Engineering Change Notification

DZH size 32...63: Profile Flat cylinder with new sensor slots
Introduction of product change

Project No
274031

Project Title
DZH Profile change

Previous Version	Future Version
DZH with sensor rail and sensor (SMB-1)	DZH with T-slot and sensor (SMT-8M...)

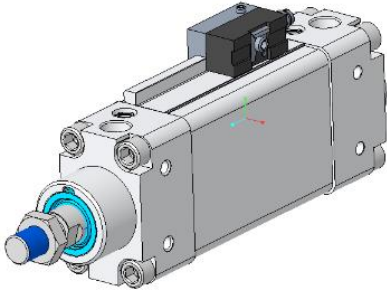
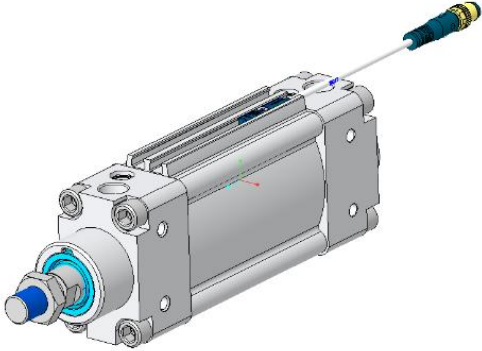
The DZH cylinder is redesigned with an optimized profile design, which enables the use of actual and price-attractive T-slot sensors (e.g., SMT-8M-A).

The product change affects the profile of the DZH size 32, 40, 50 and 63.

- **Function**
New profile with T-slot for actual sensors portfolio.
- **Environment**
The assessment of the changes shows no impact on the environment.
- **Interfacing**
No change of customer interfaces or product specification.
- **Appearance**
Visible different design of the profile
